Tesla, Inc. Service Bulletin		<h2 style="margin: 0;">Remove Side Apron Seals And Install Clips</h2>	
SB-24-12-004 May 29, 2024			
Classification Repair Bulletin		Section/Group 12 - Exterior Fittings	Mobile Service Can Perform (where permitted)
		Configuration All	
Model Cybertruck	Model Year 2024	Country/Region North America	Build Location Giga Texas
<small>The model(s) and model year(s) listed are a general approximation of the affected VIN list. Refer to the VIN/Bulletin Tracker or Customer/Vehicle profile to determine applicability of this bulletin for a particular vehicle.</small>

Figure 1

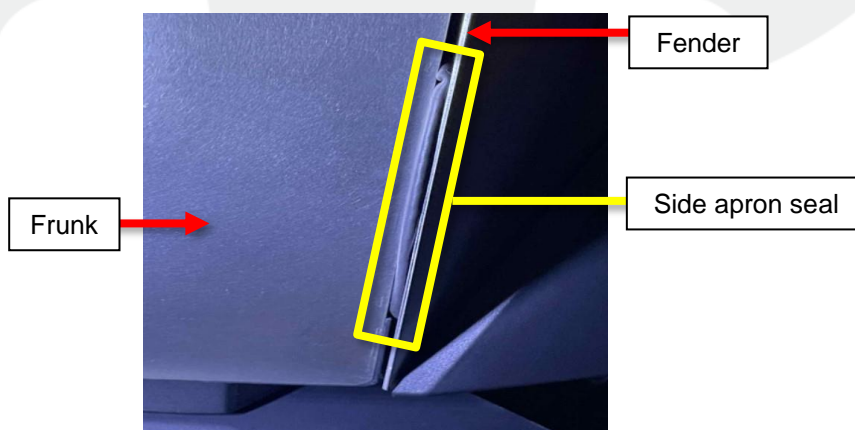
On certain Cybertruck vehicles, the LH and/or RH side apron seal may be visible through the frunk-to-fender gap (Figure 1).

Upon customer complaint, remove and discard the LH and RH side apron seals, and then plug the holes in the LH and RH side apron assemblies with clips.

Figure 2 - LH shown; RH similar

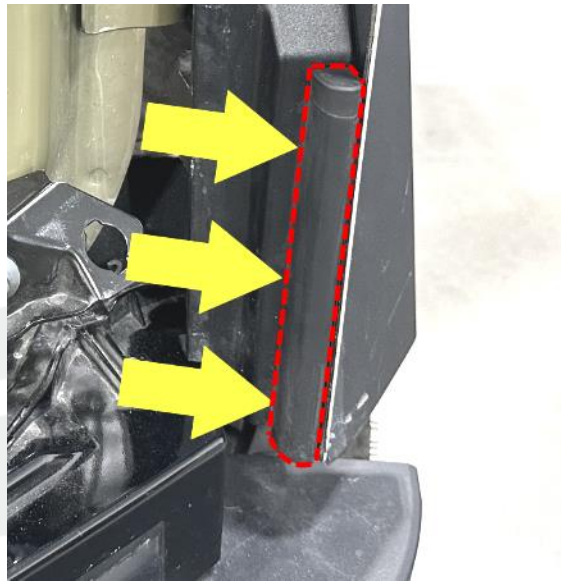
2. Use a prytool to release the clips (x3) that attach the LH side apron seal to the side apron assembly (Figure 2). Remove and discard the seal, and then repeat this step on the RH side apron seal.
